CITY OF ALBUQUERQUE

RE: 2913 12th St. NW
Grading and Drainage Plan
Engineer's Stamp Date: 04/24/23
Hydrology File: H13D118

Based upon the information provided in your submittal received 04/24/2023, the Grading & Drainage Plan is approved for Grading Permit (earthwork can get started for the earth pad on the house and retaining walls).

ENGINEER'S SEAL DAVID SOULE NEW MEXICO REGISTERED PROFESSIONAL ENGINEER 14522 4/24/23 DAVID SOULE P.E. #14522	LOT 7-A COLEMAN ADD. 2913 12TH STREET GRADING AND DRAINAGE PLAN P.O. BOX 53924 ALBUQUERQUE, NM 87199 (505) 321-9099	DRAWN BY DEM
		DATE 4-22-23 SHEET # C1 JOB #

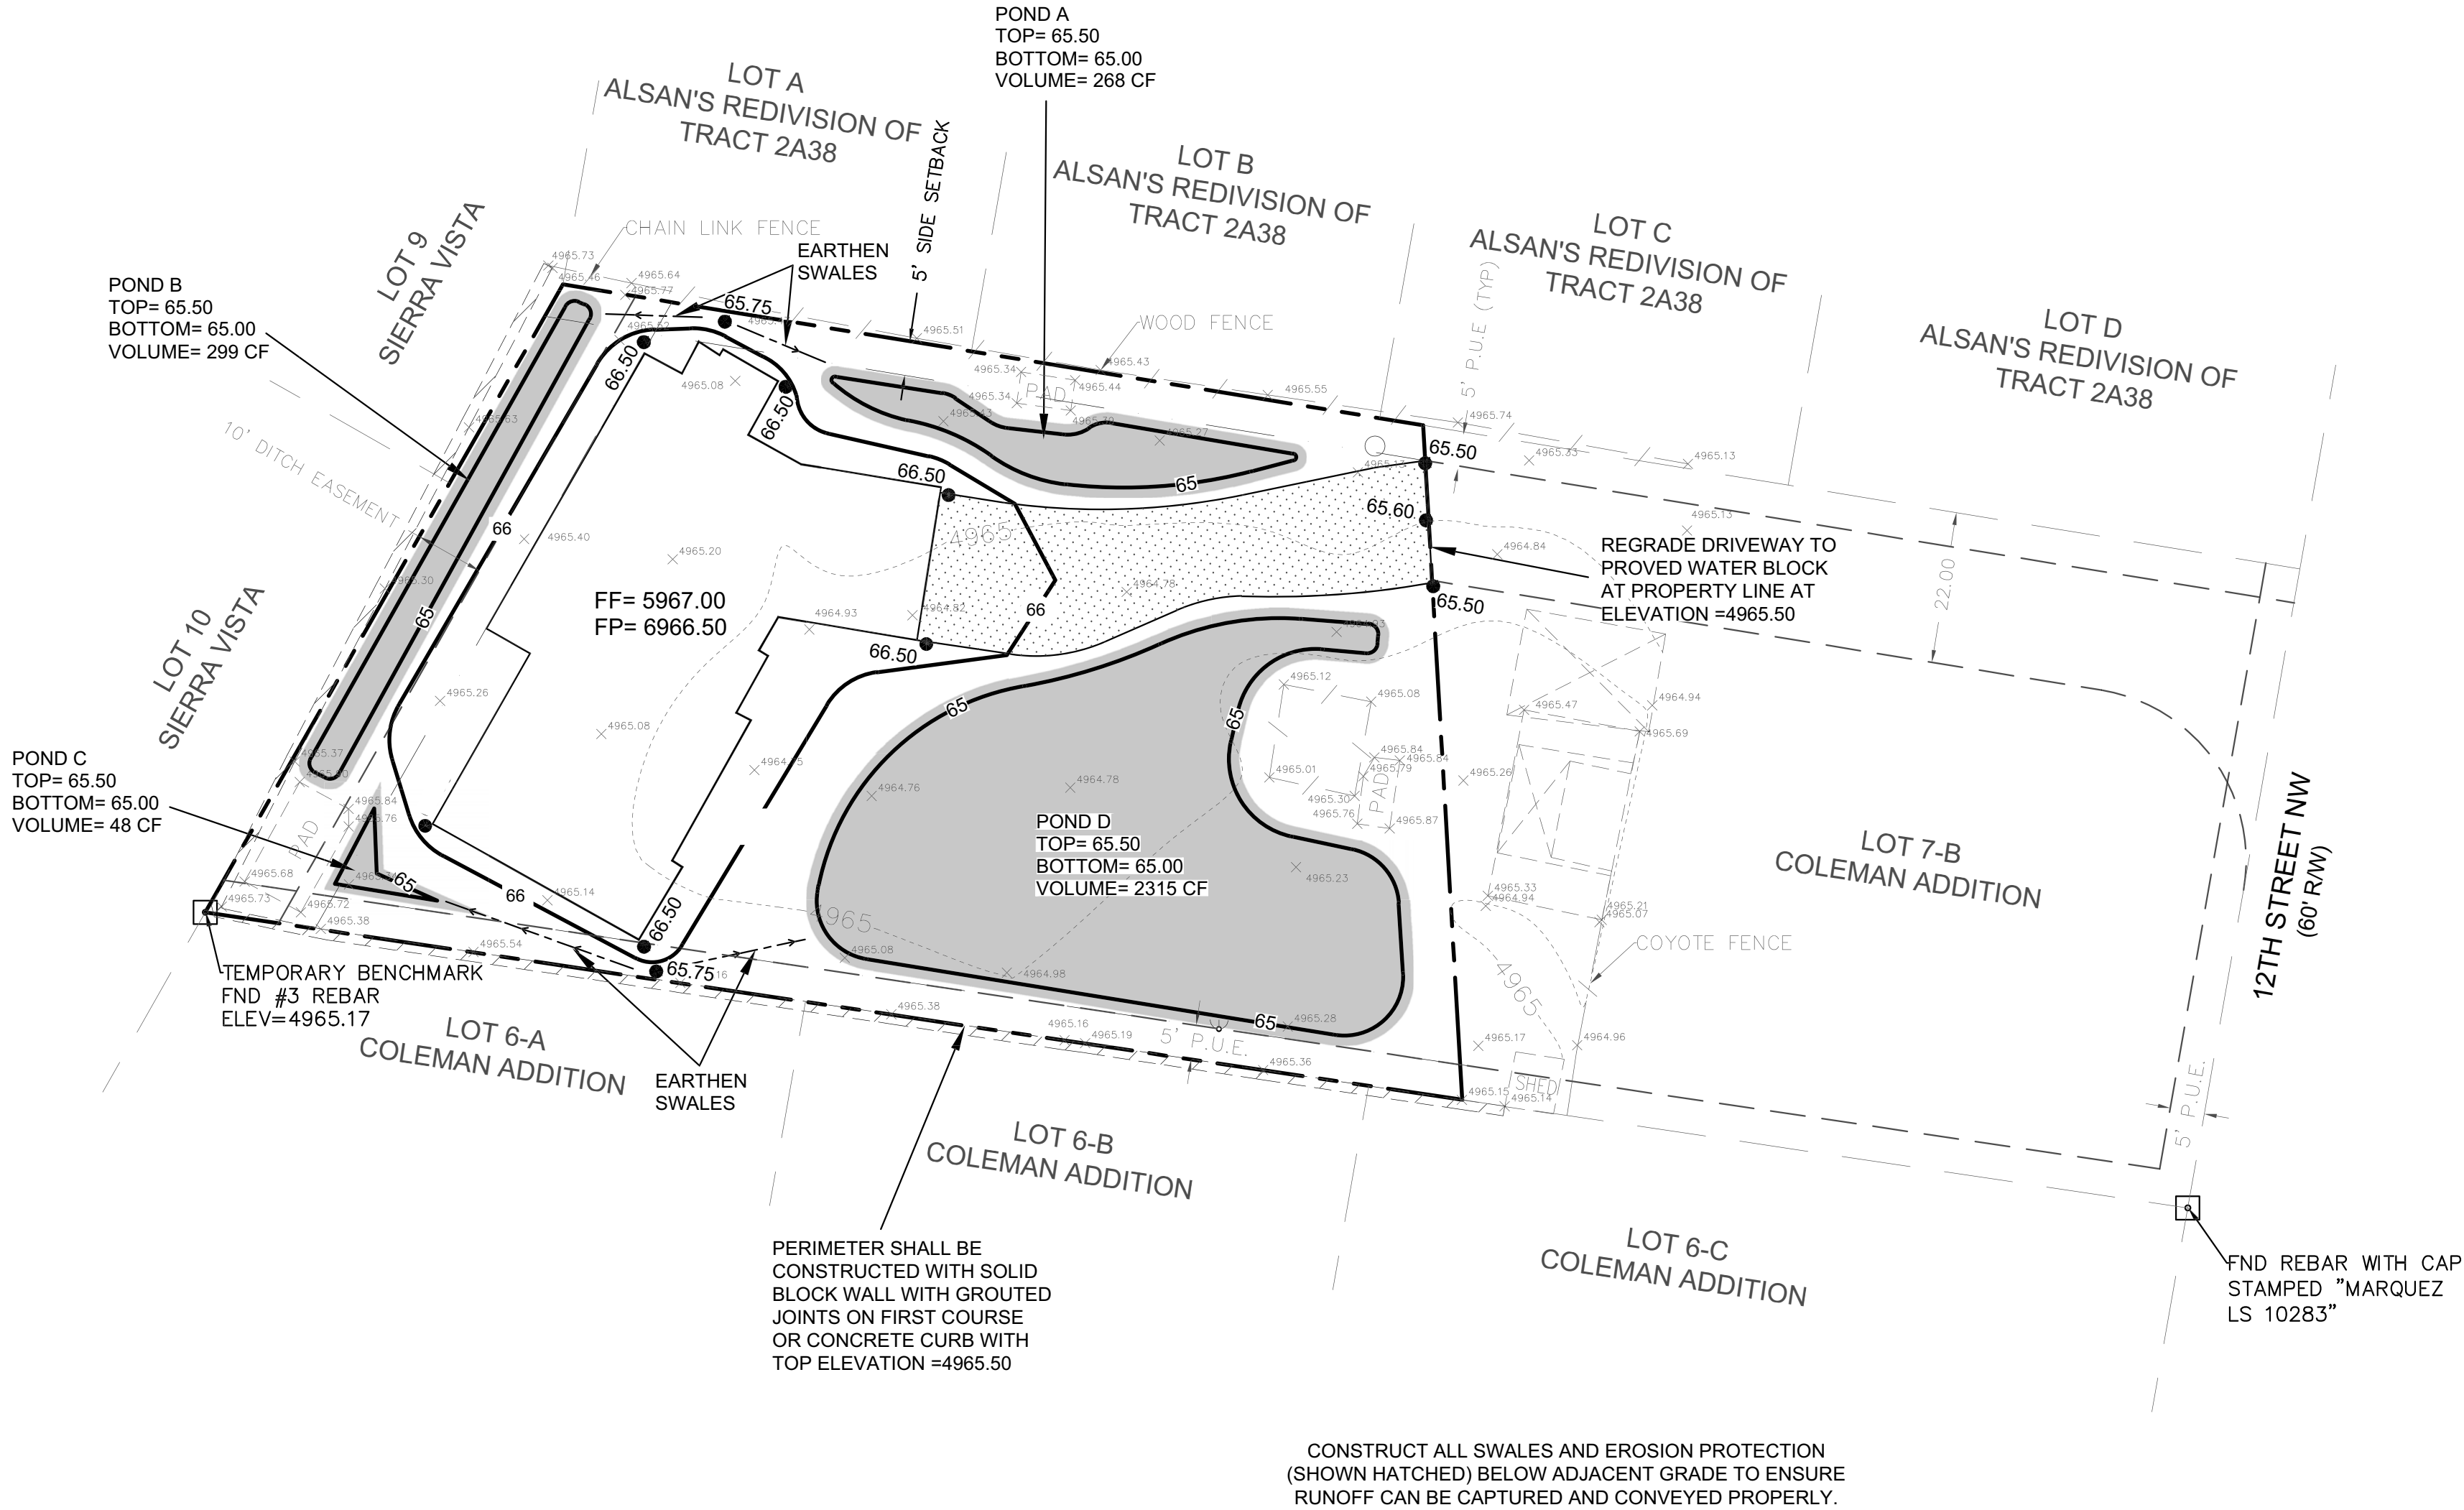
1. Once the grading is complete, a pad certification (meaning that the earthwork and retaining walls are complete) will be required. Please include a site photo with the submittal. Also, at the time of pad certification approval, Hydrology will concurrently approve the Grading & Drainage Plan for Building Permit.
